**CITY OF NOVI CITY COUNCIL**  
**MAY 20, 2024**

**SUBJECT:** Consideration of tentative approval of the request of Toll Brothers, LLC, for Elm Creek, JZ22-28 with Zoning Map Amendment 18.732, to rezone property on the west side of Meadowbrook Road, south of 12 Mile Road from Office Service Technology and Low-Rise Multiple Family to Low-Rise Multiple Family with a Planned Rezoning Overlay.

PRO Concept Plan: Formal Submittal

Rezoning Request from OST Office Service Technology to Low-Density Multiple Family RM-1 with a Planned Rezoning Overlay

**SITE PLAN - PHASE 2**

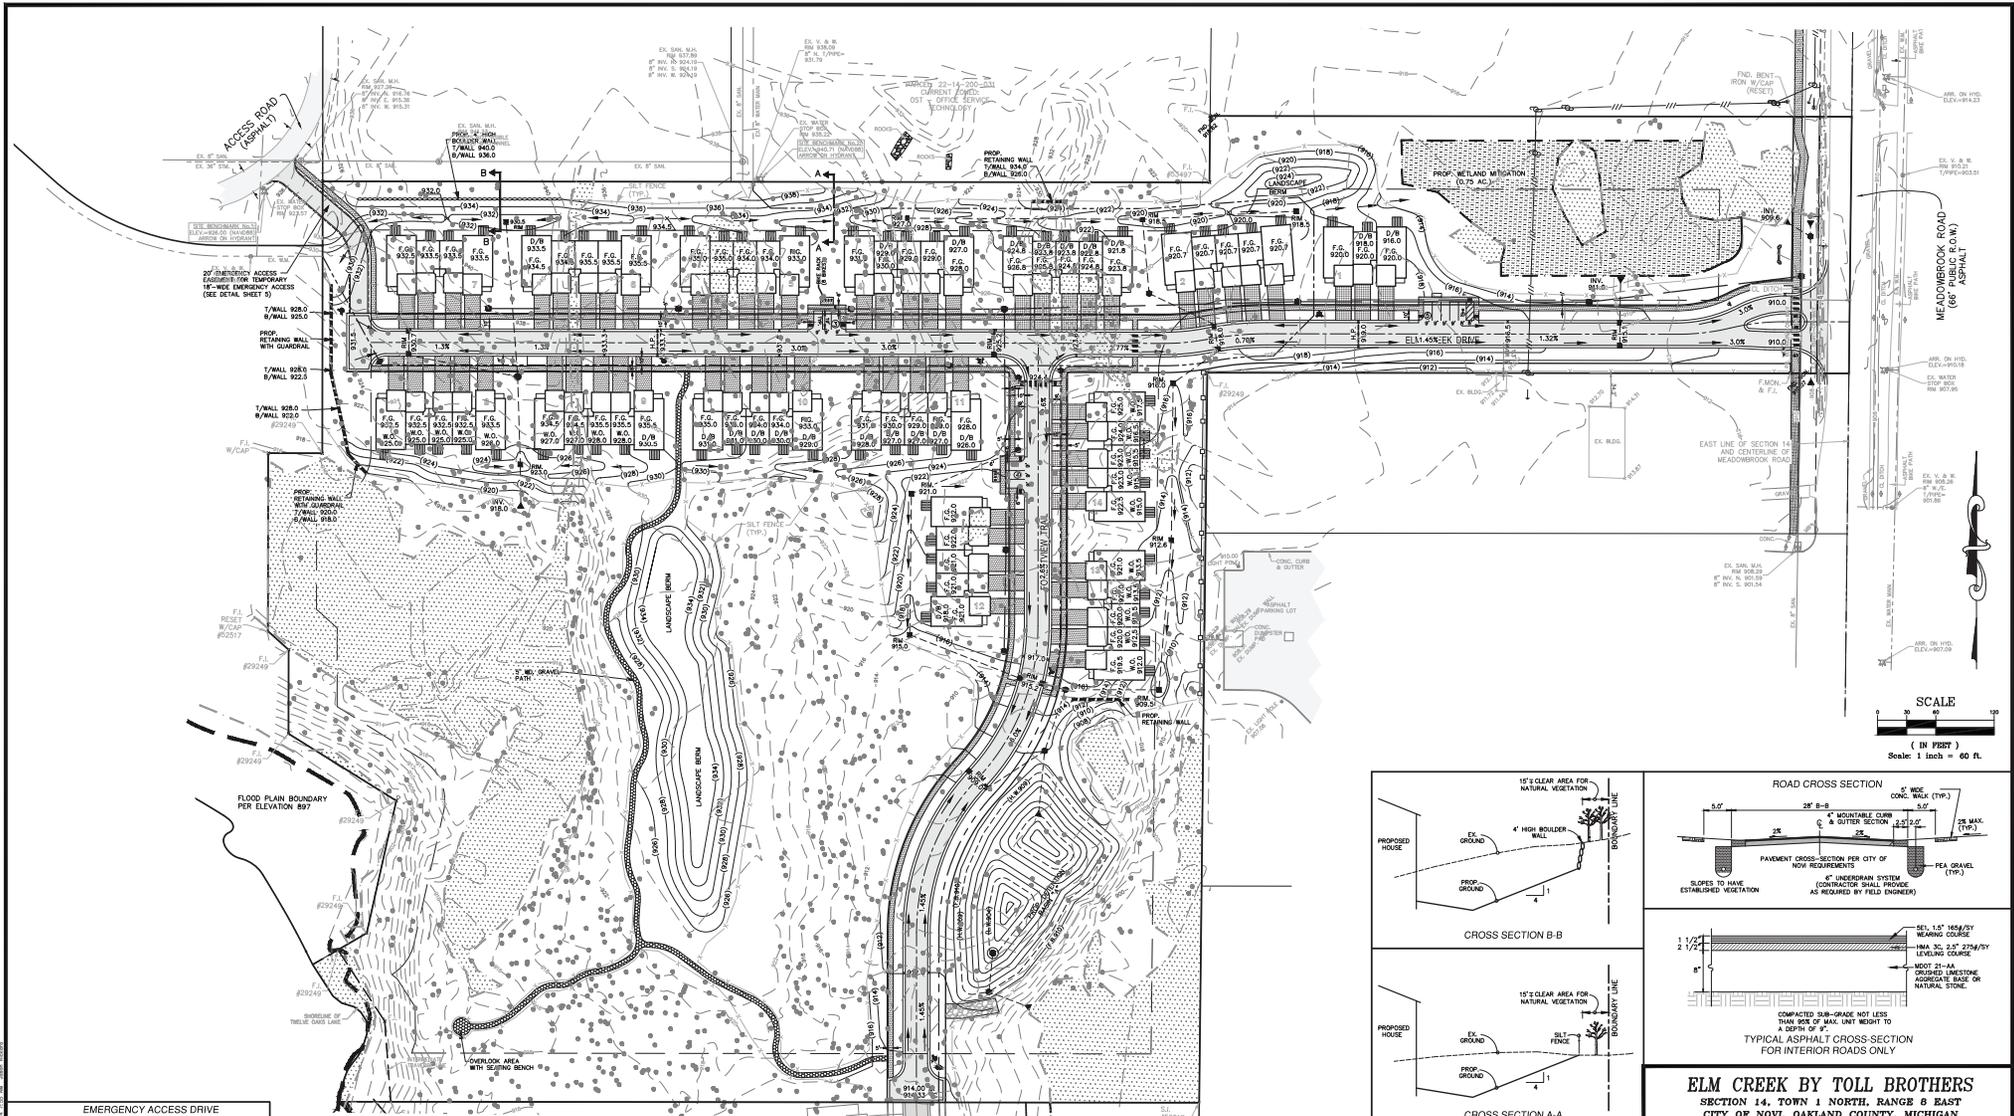
Very little detail is provided for the “Phase 2” area of the project. No boundary/topographic survey is provided for the southern area (ie, that area owned by Singh), and no tree survey is provided. The proposed plan for the southern area is very conceptual. Any development proposed for the phase 2 area would require an amendment of the PRO Agreement by all parties if it does not conform to the agreed upon terms.

6. Screening between adjacent properties including fences and landscaping as shown in the PRO Plan.
7. A cul-de-sac shall be provided at the terminus of the road in Phase 2 rather than a temporary T-turn, since it is unlikely that the road will connect to future development to the south. If Phase 2 of the project does not move forward in a timely manner, the temporary T-turnaround shall be changed to a cul-de-sac.

OPEN SPACE PLAN

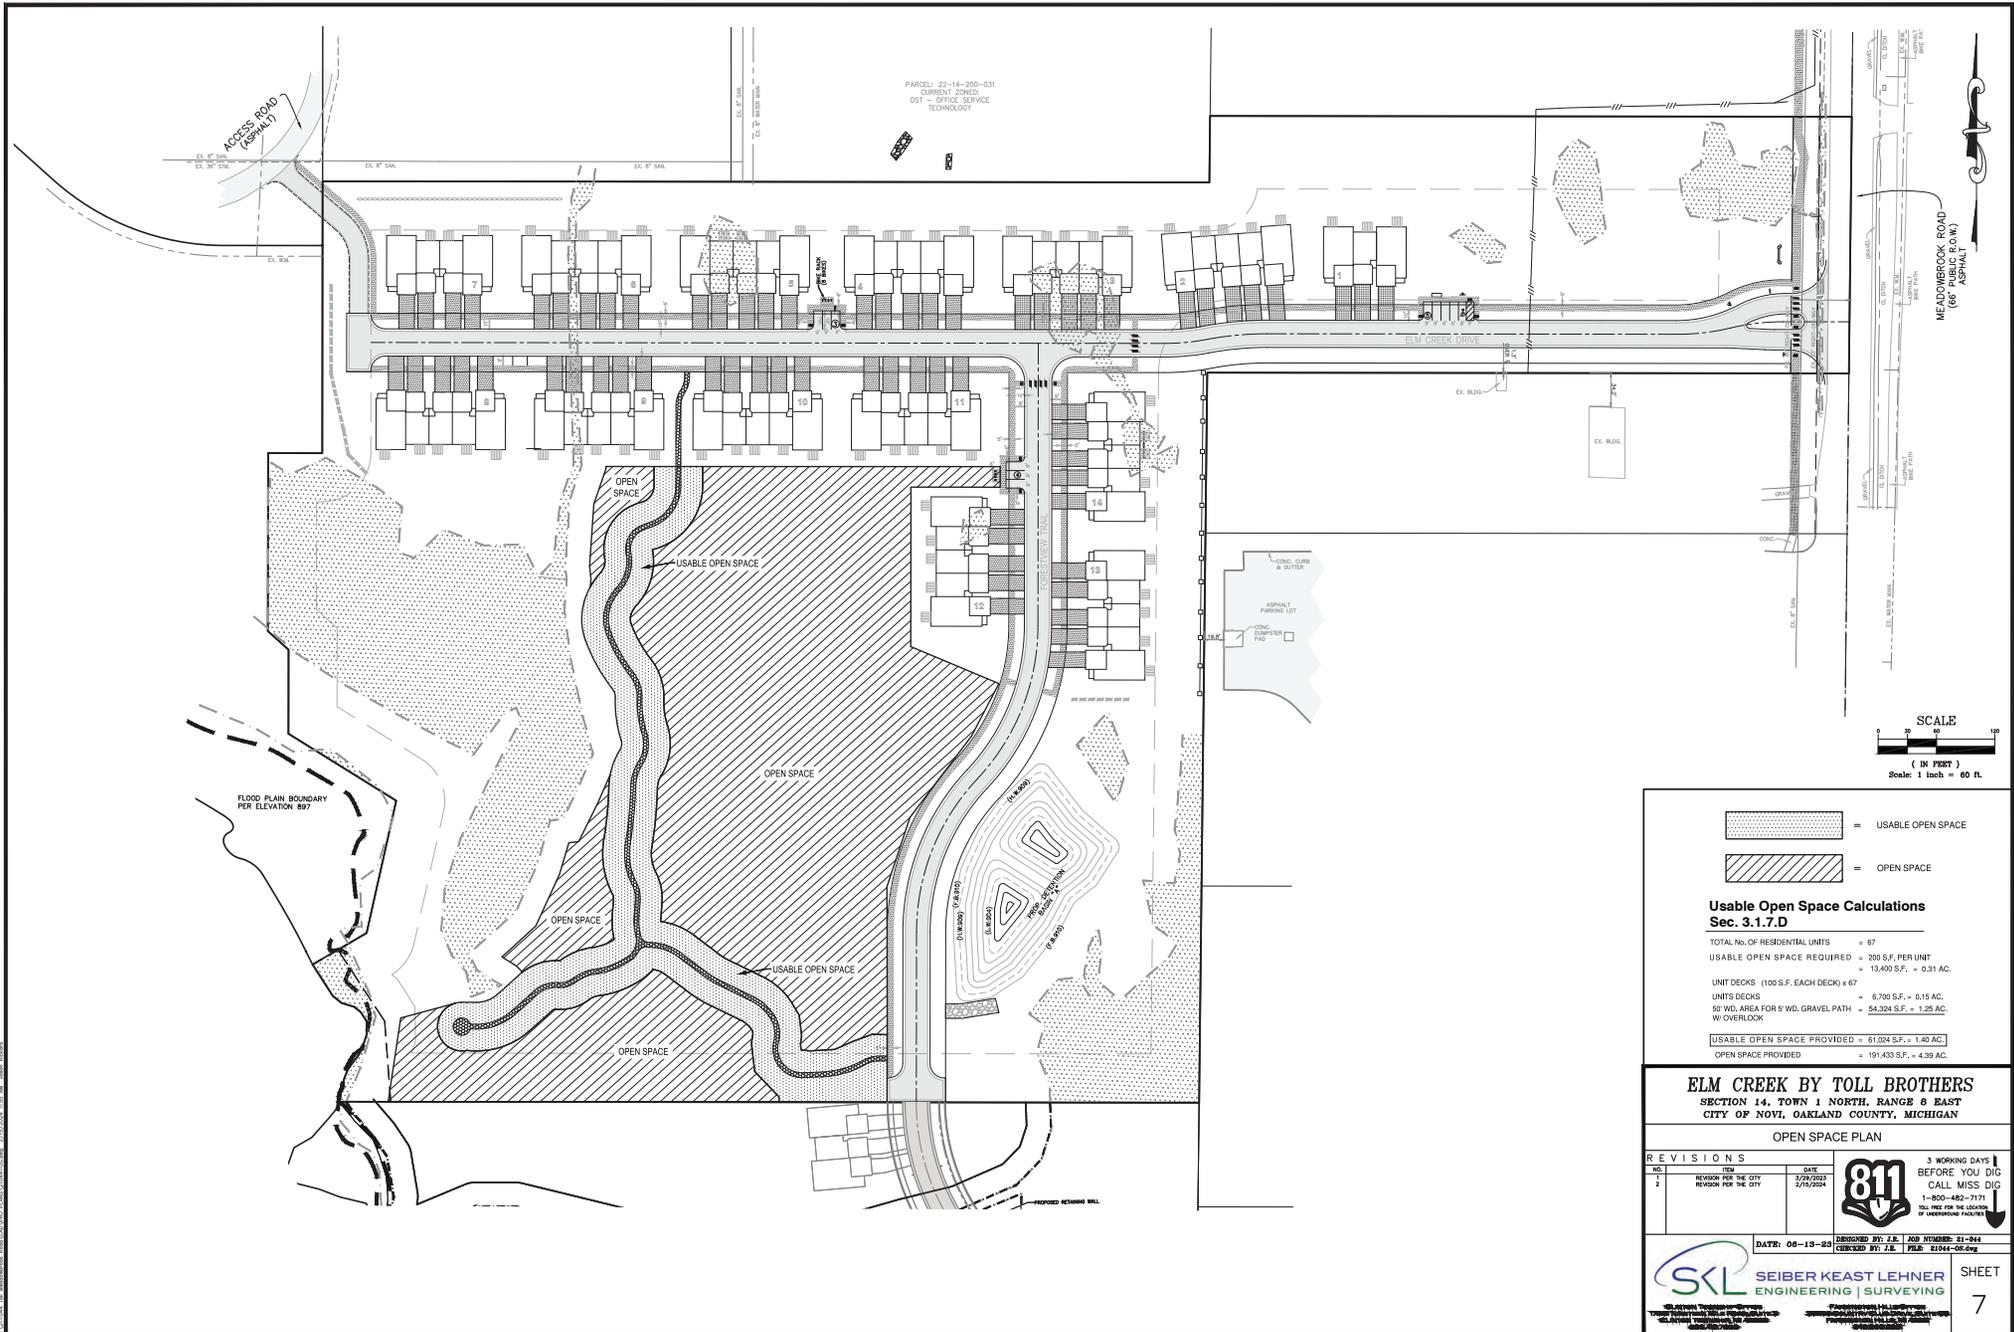
3. Usable Open Space: The applicant has stated the deck/patio space on the units are a standard element of construction. The applicant has also indicated a 50-foot width with the 5-foot gravel pathway in order to qualify as usable open space. The walking pathway has also been rerouted to create a loop, and an overlook area is proposed on the western end. **A similar looped pathway is also proposed for the Phase 2 portion, however the exact area included in the calculation is not shown on the plan.**

Title:  
**Conceptual Landscape Plan**

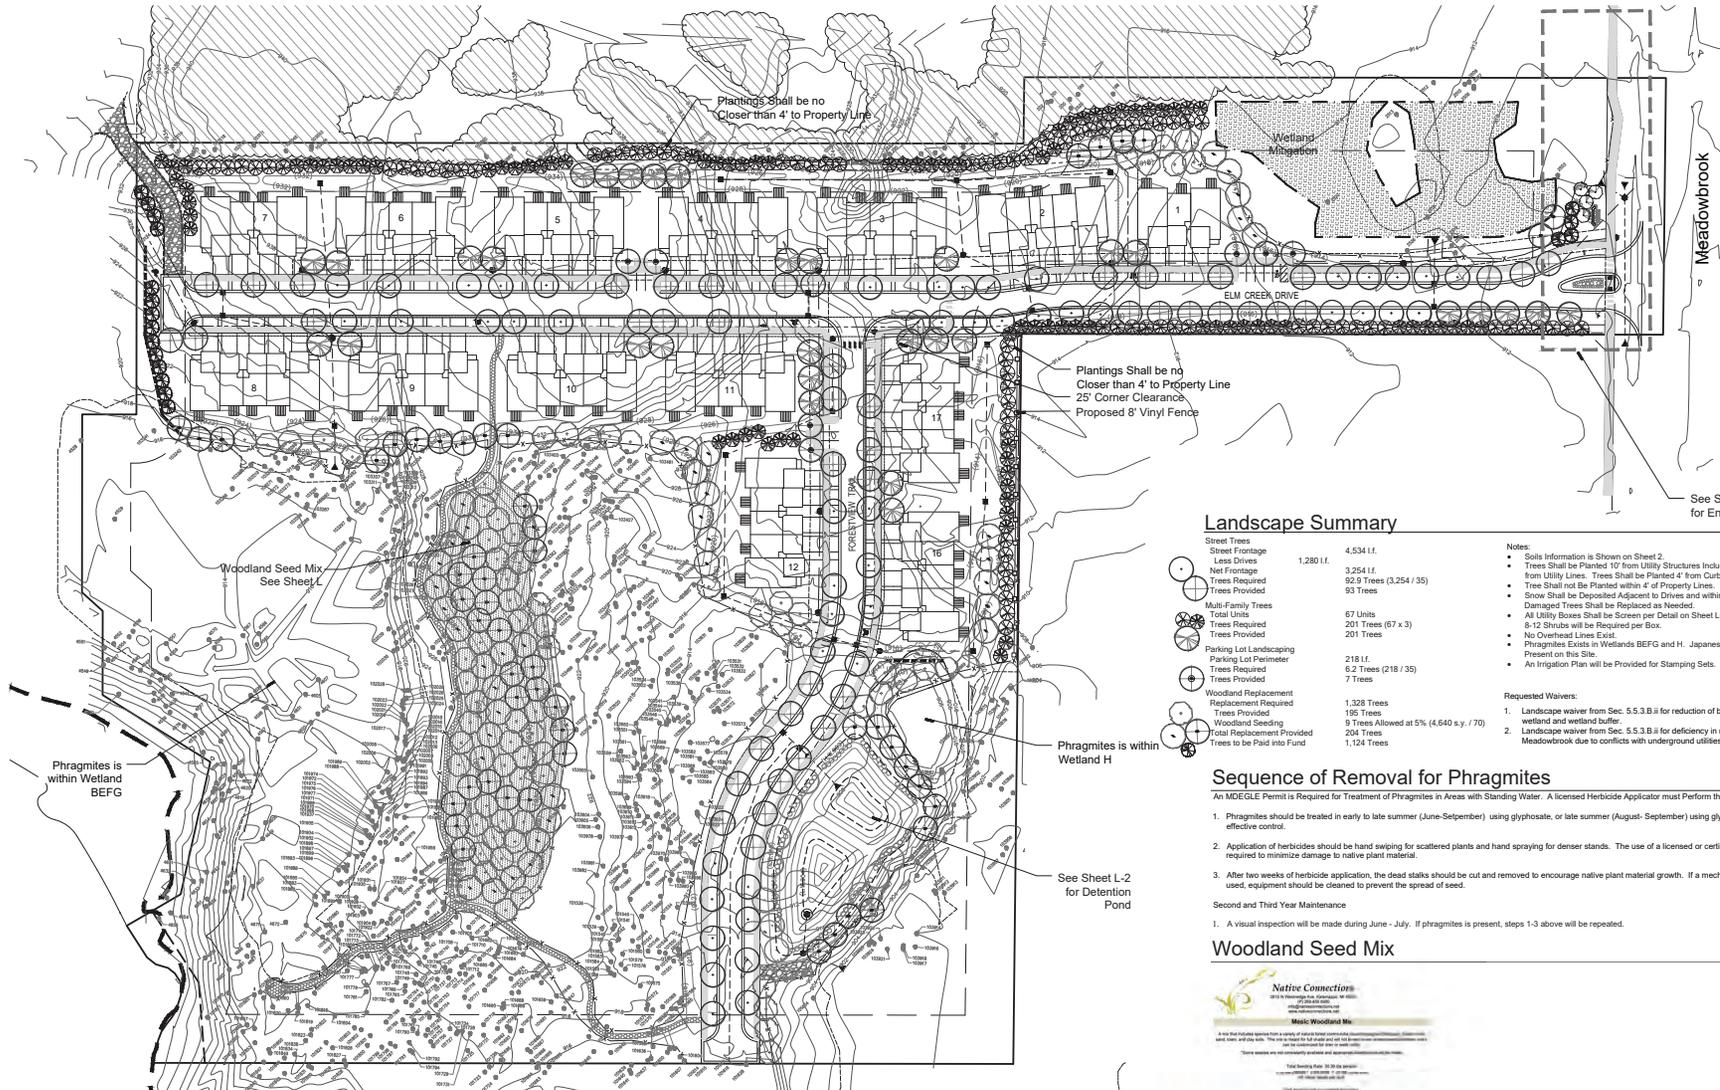
- a. DRG requested that the cost to stake, install, and remove the tree protection fencing be added to Sheet L-3 in order to calculate woodland fence inspection fees. Prior to final site plan approval this should be added to either Sheet L-1 or L-3.
